SUBDIVISION REVIEW SHEET

CASE NO.: C8-2014-0015.0A

SUBDIVISION NAME: Theodore Low Heights Portion of Blk 24; Resubdivision

SUBJECT: C8-2014-0015.0A Theodore Low Heights Resubdivision of a portion of Block 24

RES BDIVISION OF A PORTION OF BLOCK 24 THEODORE LOW HEIGHTS

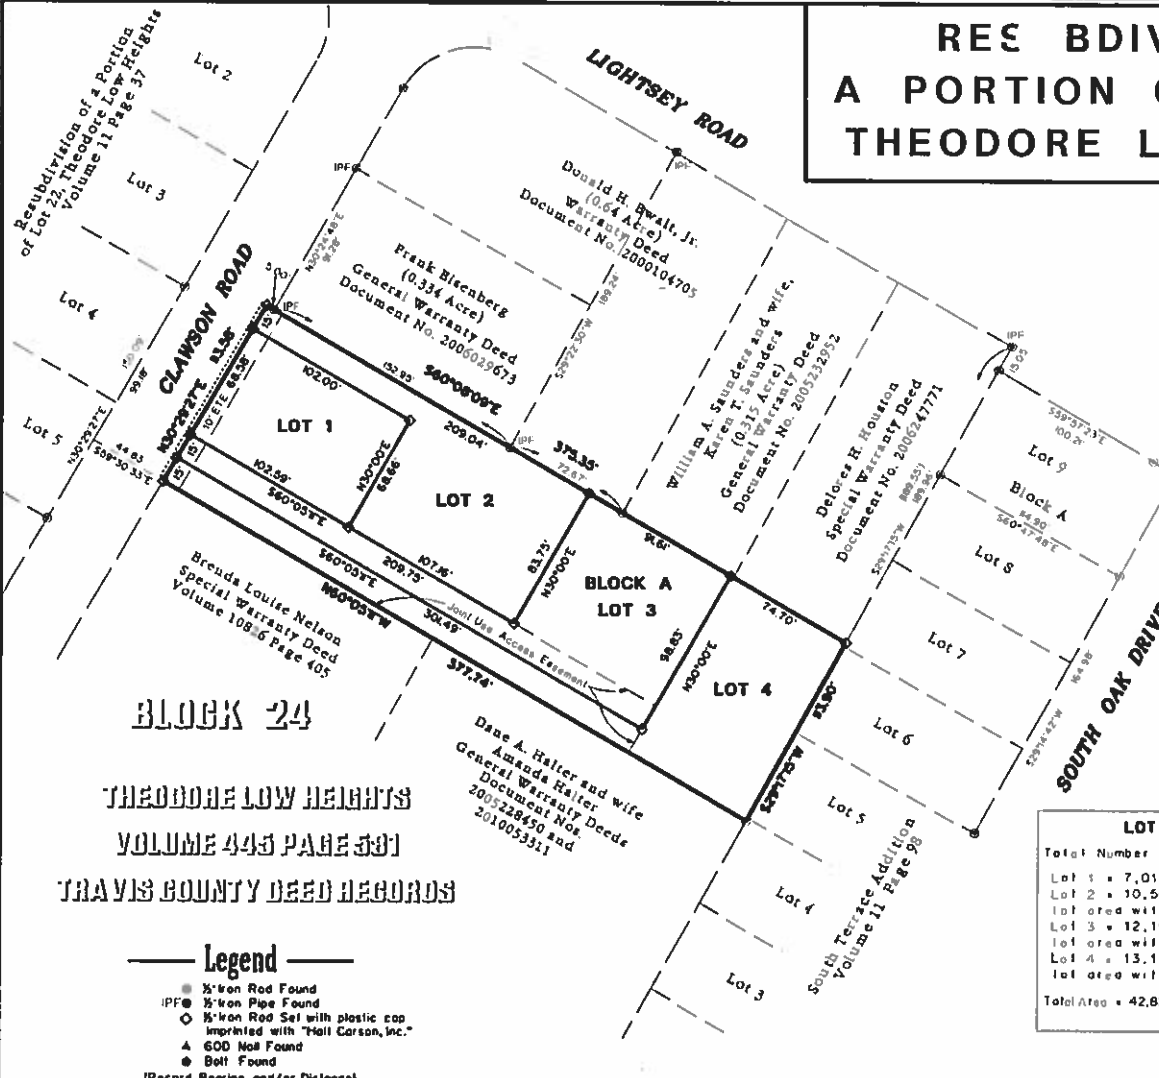
This is a lot be subdivided into flag lots. Subsequent to preliminary meetings with Carl Wren, I have met with Andre Desnoyers and verified that the proposed plat for the above referenced project has a sufficiently sized joint use access easement to provide the required fire lane and fire dept. turn-around.

The fire lanes are not generally shown on the plat. To ensure that AFD reviews the fire lane before BP approval, I have added the following note to the conditions of C8-2014-0015.0A:

Plan showing fire lane will need to be approved by the Austin Fire Dept. as part of the Building Permit approval.

FLAG LOT MAP

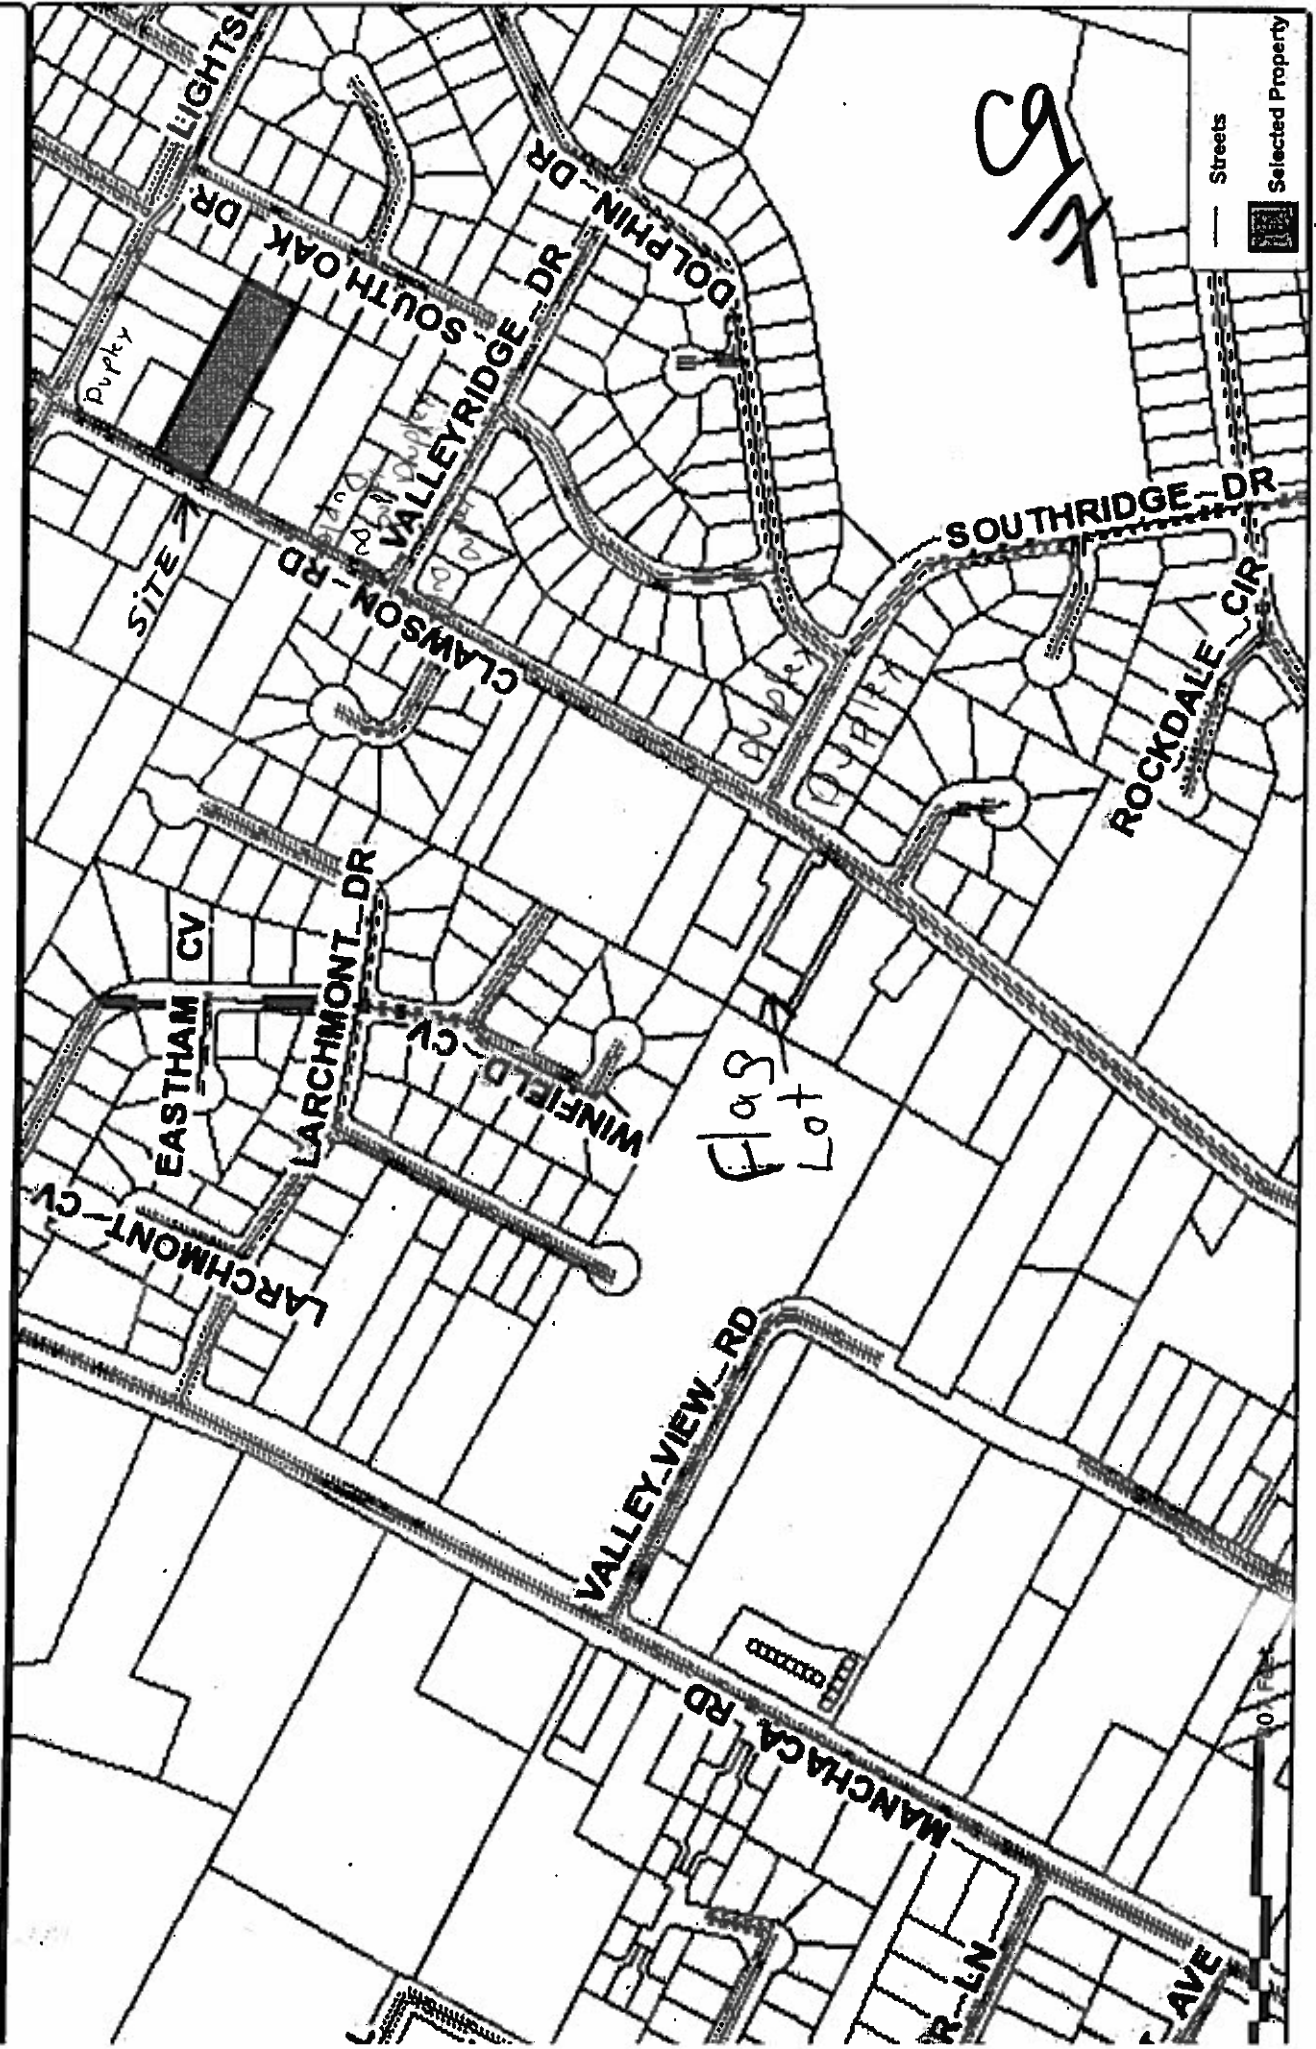
The applicant has provided an exhibit, (see attached, Flag Lot Map Exhibit) which generally shows the development pattern in the immediate vicinity. According to the map provided, (attached), there is an existing flag lot in the neighborhood and the area is heavily developed with duplexes. Based upon the map provided, staff believes that a flag lot design is compatible with the surrounding neighborhood.

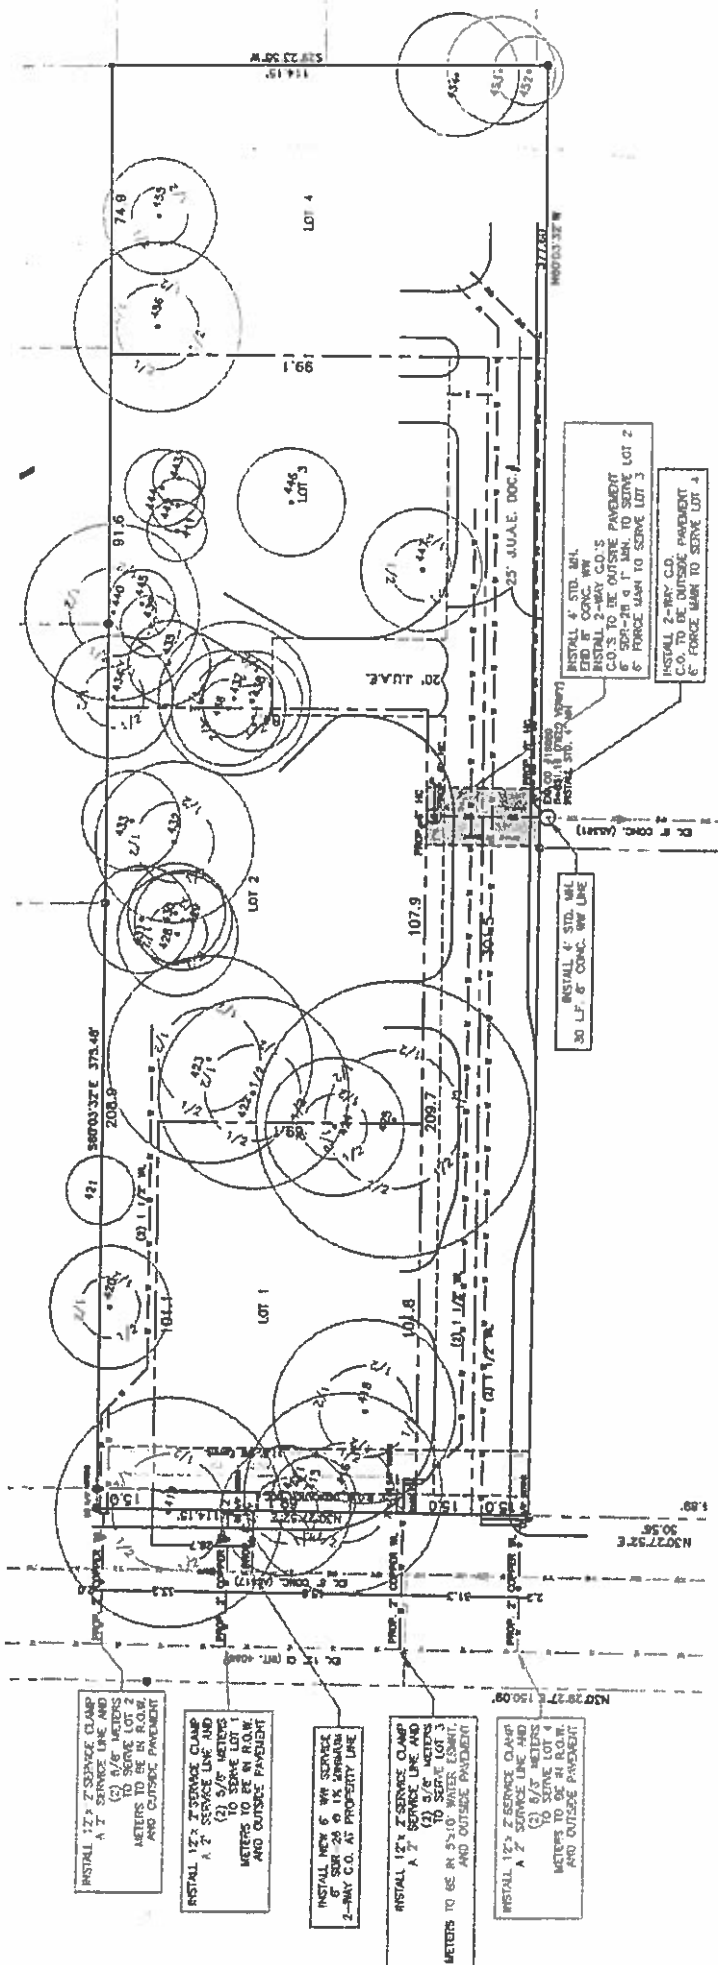
The applicant has provided a driveway and utility plan to reviewers for the City of Austin Water and Wastewater review and Austin Energy Departments. The reviewers have determined after review of the utility/driveway plan that there is adequate room to provide utility service to both lots and utilities will not cross the proposed new lot lines.

The proposed Resubdivision Theodore Low Heights Portion of Blk 24, case #C8-2014-0015.0A, is approved from a plumbing code perspective.
